Commission of Architectural Review

1. COA-179902-2026	Final Review	Meeting Date: 2/24/2026
Applicant/Petitioner	Matt Jarreau	
Project Description	Reconstruct a previously removed front porch	
Project Location		
Address: 2807 East Clay Street		
Historic District: Church Hill North		
<p>High-Level Details:</p> <p>The applicant proposes to reconstruct a full-width front porch at 2807 East Clay St, a Greek Revival building that retains many of its defining architectural features. The house features a prominent front-facing gable with a defined pediment, wide frieze, and an oculus window at the attic level. The original window openings remain intact, and the primary entrance retains its transom and sidelights. The project proposes to reconstruct a simpler full-width porch.</p>		
Staff Recommendation	Approval, with Conditions	
Staff Contact	Yara Iwaz, Yara.Iwaz@RVA.gov, (804)646-6031	
Previous Reviews	<ul style="list-style-type: none"> N/A

Figure 3: Sanborn Map, 1925, showing a porch and side addition that have since been removed

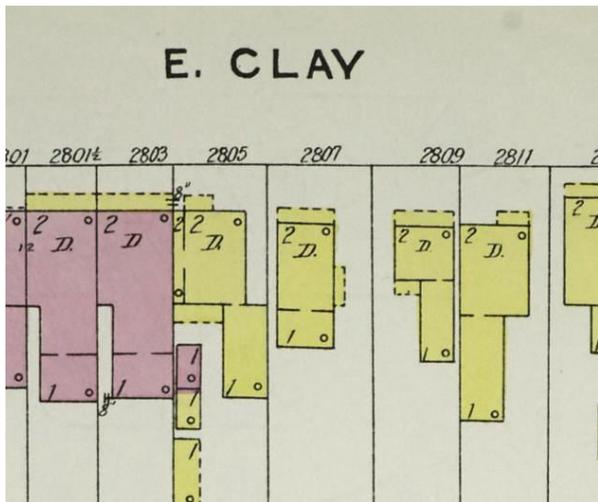
Standards for Rehabilitation, p.59	<i>1. Retain original features and materials that define the building style, including but not limited to wood siding, shingles, stucco and masonry.</i>	The application does not specify gutter treatment. <u>Staff recommends submitting final gutter and downspout design built into the porch roof assembly for staff review and approval. Design should match the profile of the original, as seen in the 1950s historic photos.</u>
		The submitted isometric drawing shows a potential reconstruction of a previously removed side addition (sunroom-style projection) and the reconstruction of the west chimney. While historic Sanborn maps and photographs indicate that these elements previously existed, they are not included as part of the current application scope. <u>Staff recommends that any proposed reconstruction of the side addition or chimney be submitted under a separate application.</u>
